DAGMIT GISHEN MARYAM ETHIOPIAN ORTHODOX CHURCH

SITE PLAN

2 NEW ADDITION MINOR AMENDMENT 3-28-19

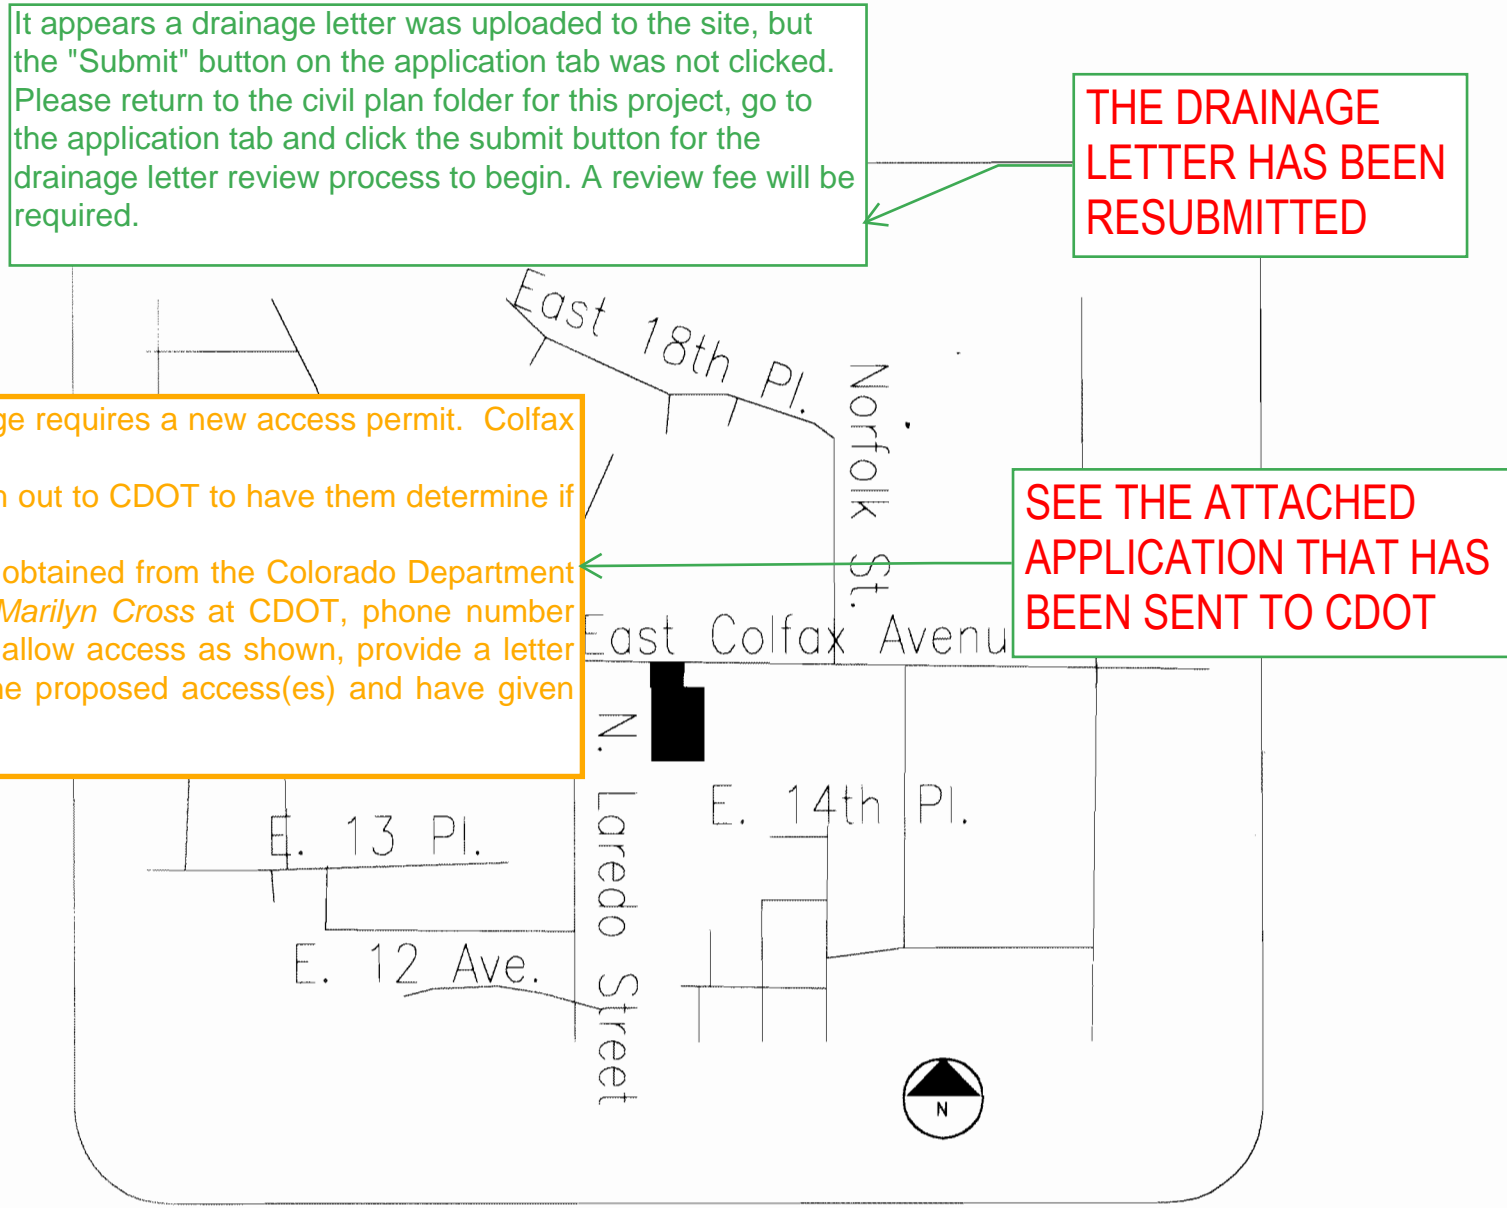
Reach out to CDOT to determine if this change requires a new access permit. Colfax Ave is a state highway. This is an extension of an existing use, reach out to CDOT to have them determine if a new access permit is required. Approval and access permits will need to be obtained from the Colorado Department of Transportation (CDOT). Please contact Marilyn Cross at CDOT, phone number 303.512.4266. In order to insure CDOT will allow access as shown, provide a letter from CDOT indicating they have reviewed the proposed access(es) and have given preliminary approval.

Tree
Mitigation

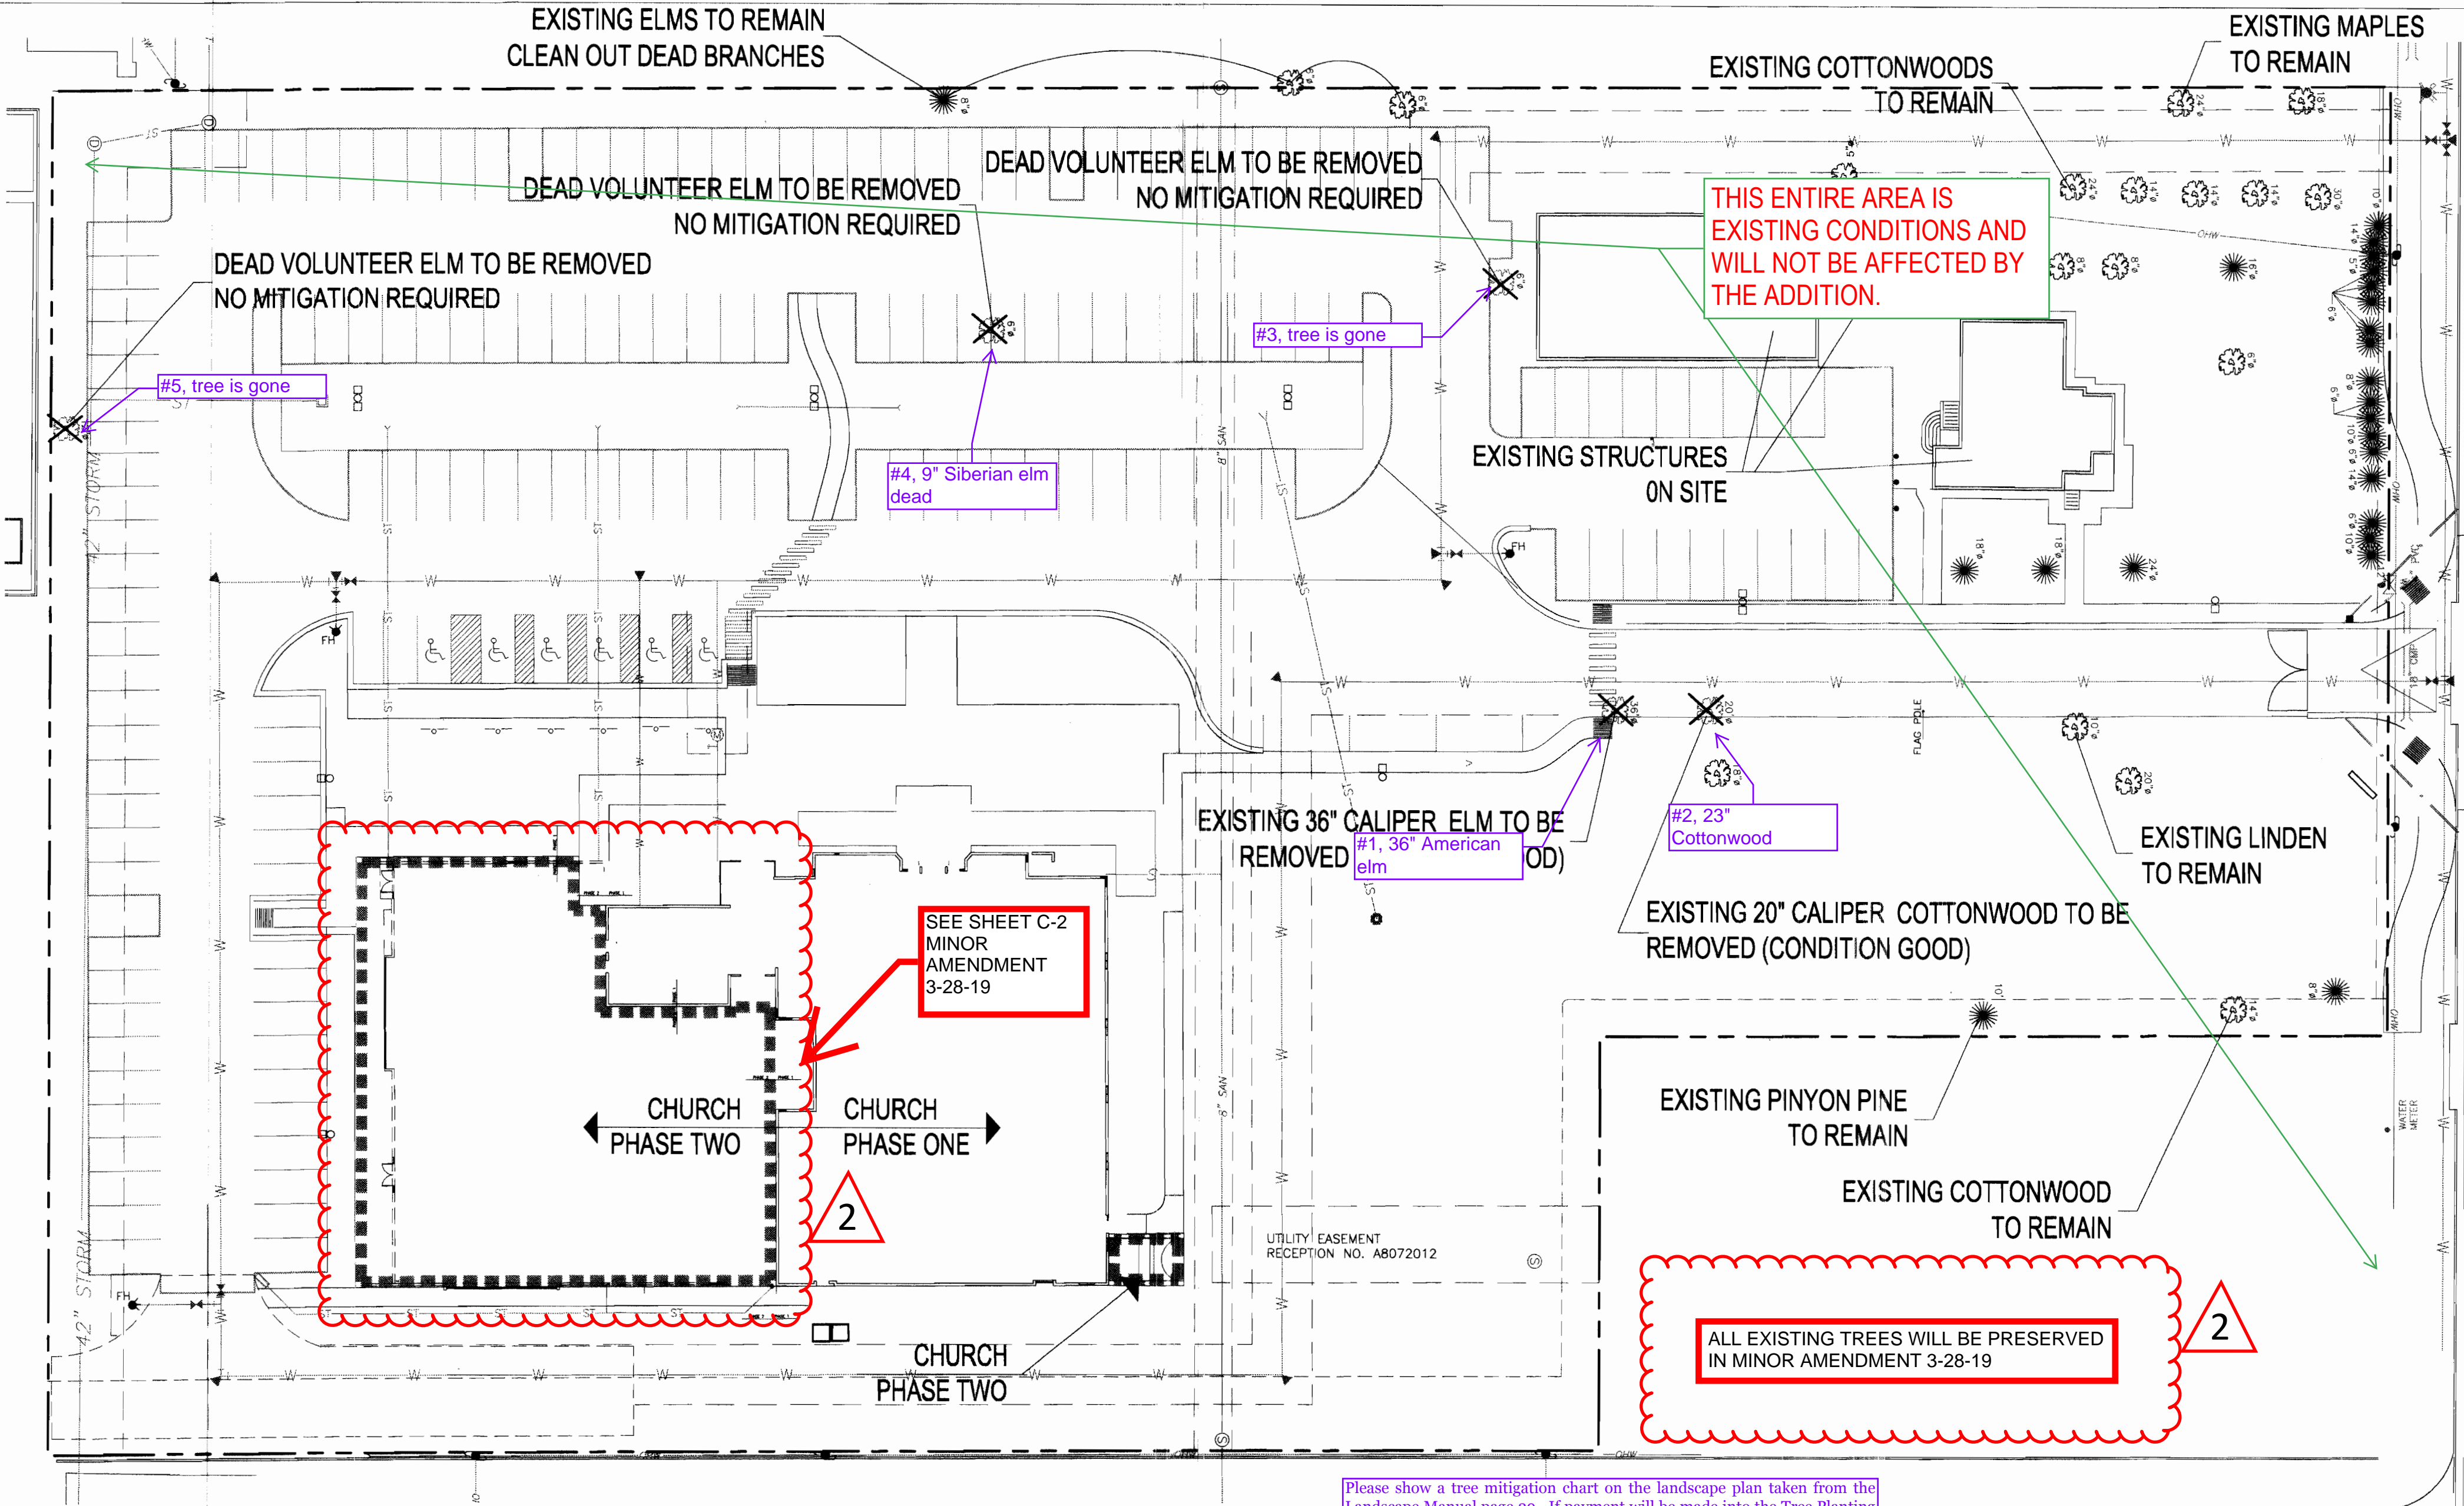
Please show a tree mitigation chart on the landscape plan taken from the Landscape Manual page 29. If payment will be made into the Tree Planting Fund, add another column to the chart indicating the payment amount that will be made. If trees will be planted on the site, please show a symbol indicating trees that are specific to tree mitigation.

NON OF THE EXISTING
TREES WILL BE AFFECTED
BY THE ADDITION

1 FIRST FLOOR PLAN

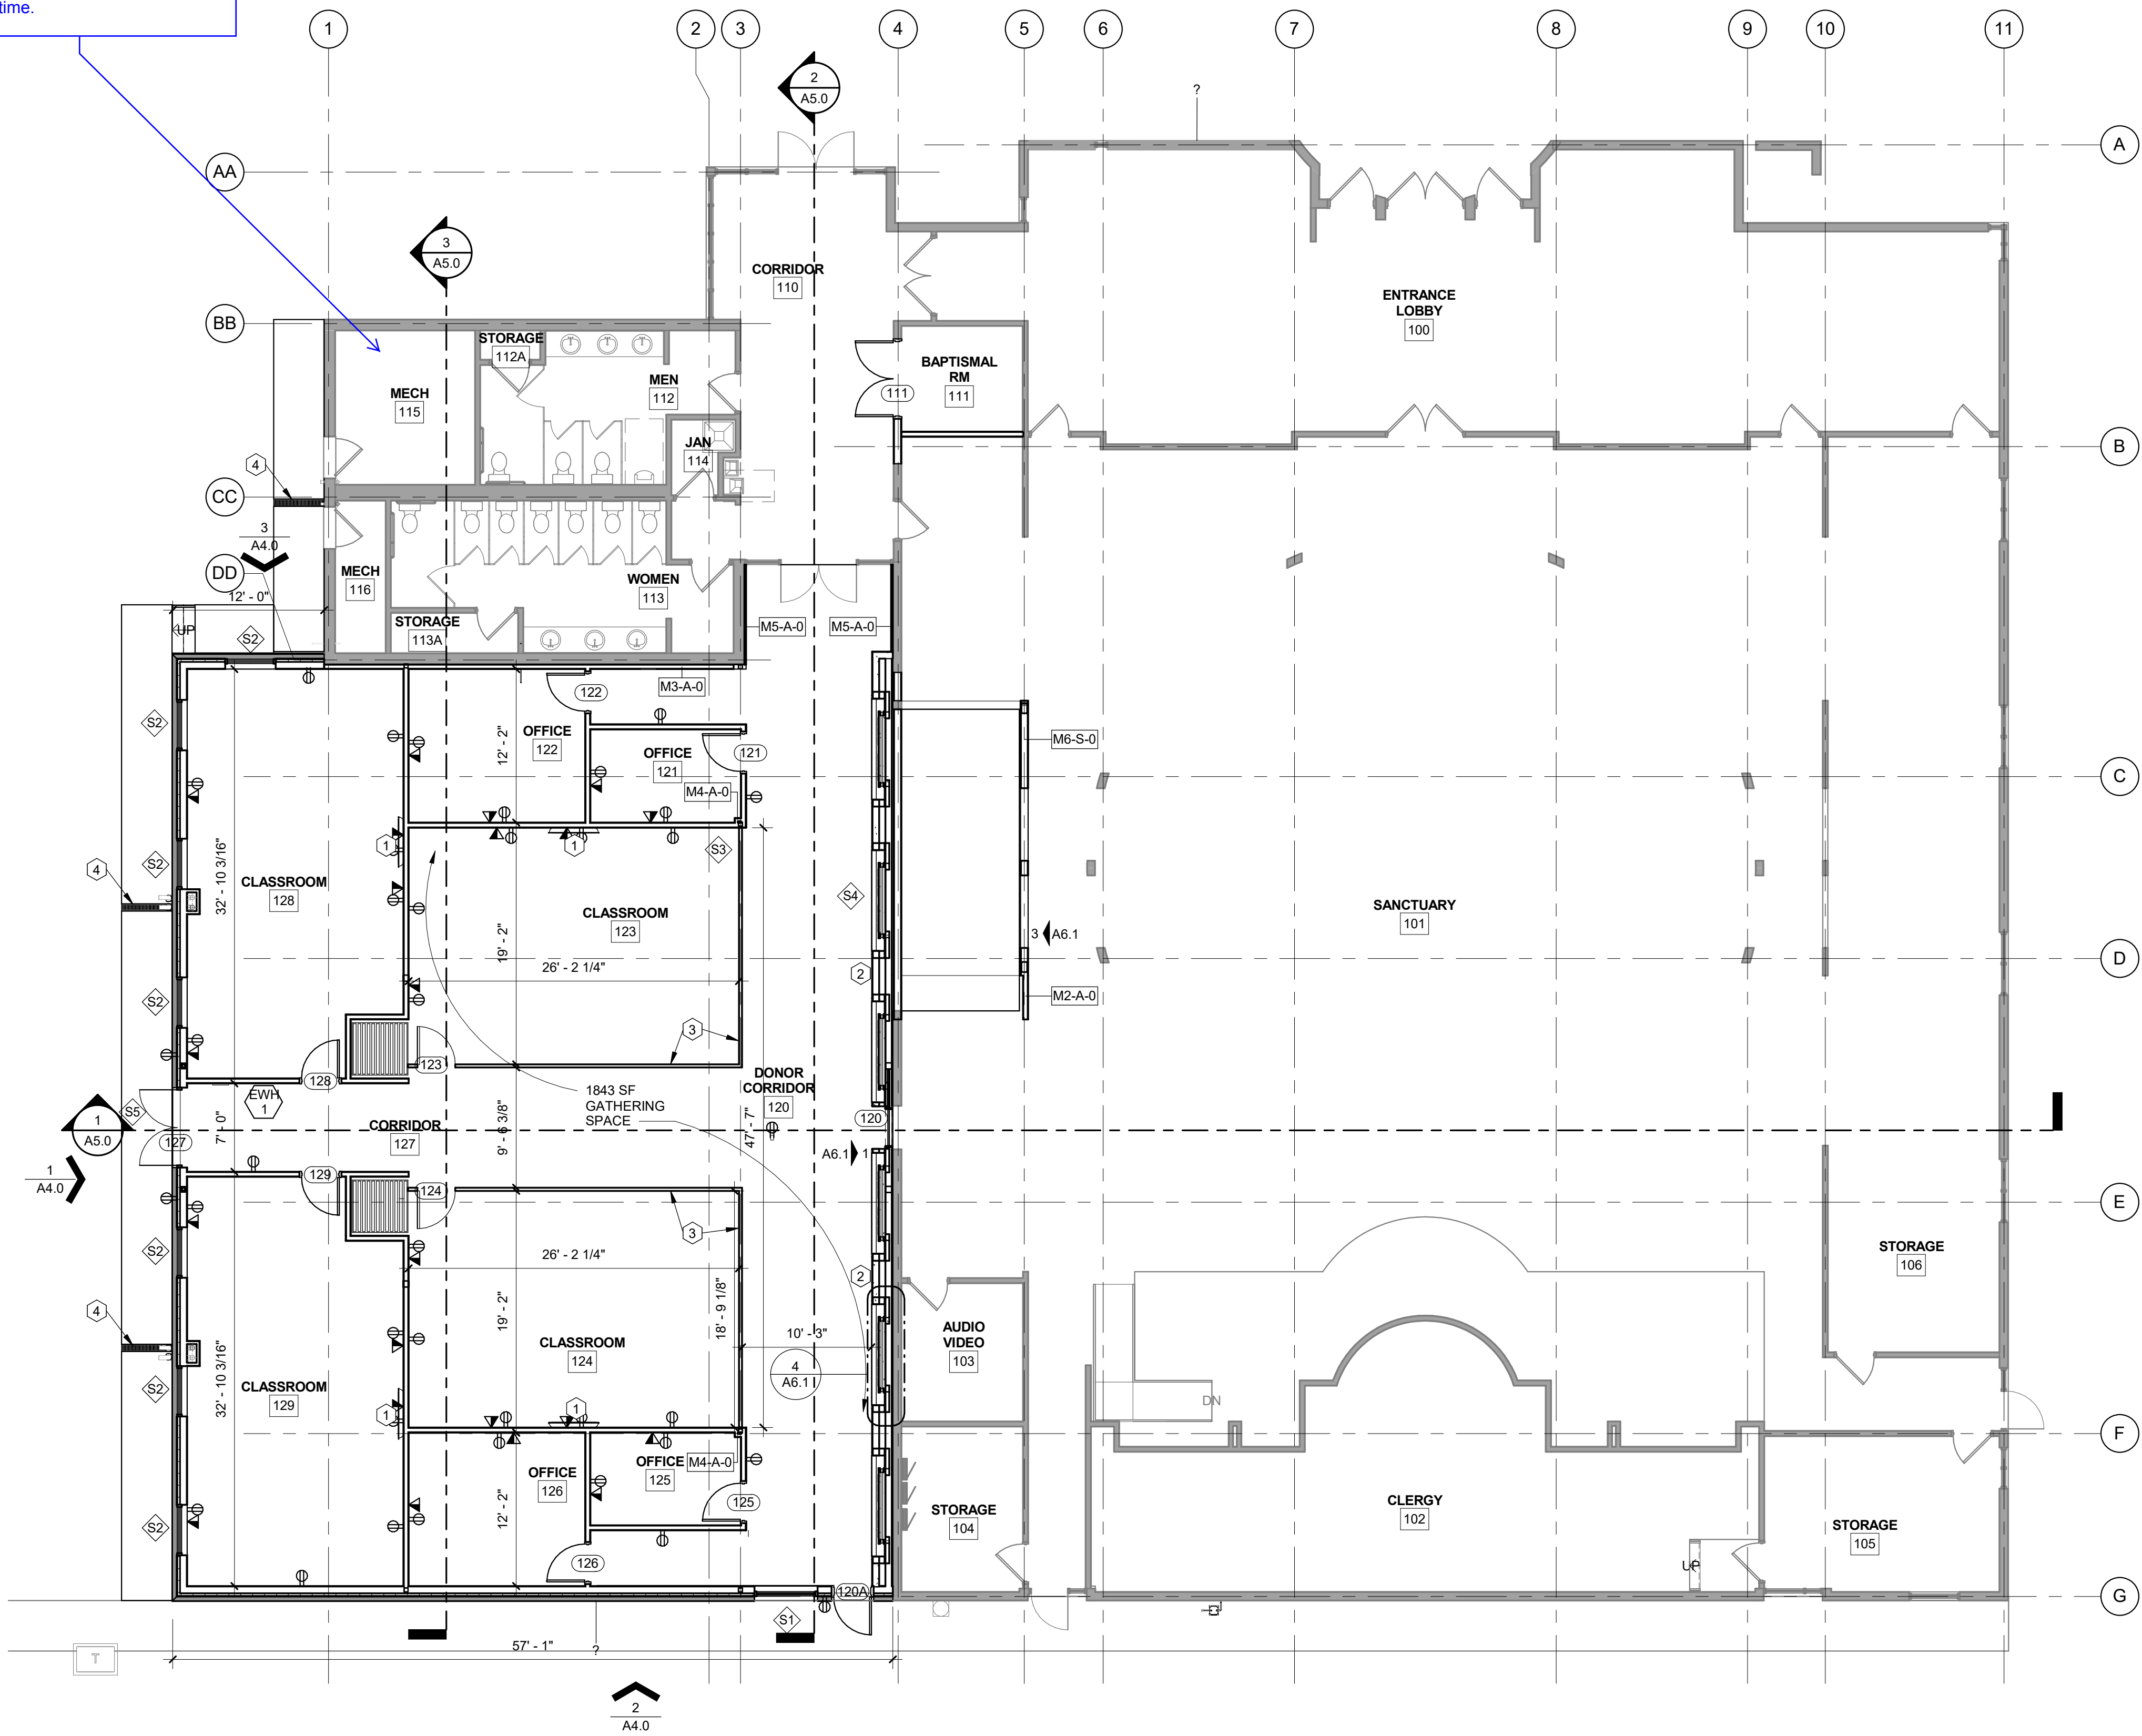
Show location of fire riser room on this sheet. Include a symbol for the fire department connection. Note: Knox caps are required to secure the openings on the fire department connection. If the door to riser room is not currently labeled, it will be required to be labeled at this time.

FIRE RISER ROOM HAS BEEN SHOWN AND A SYMBOL FOR THE FIRE DEPARTMENT CONNECTION HAS BEEN INCLUDED
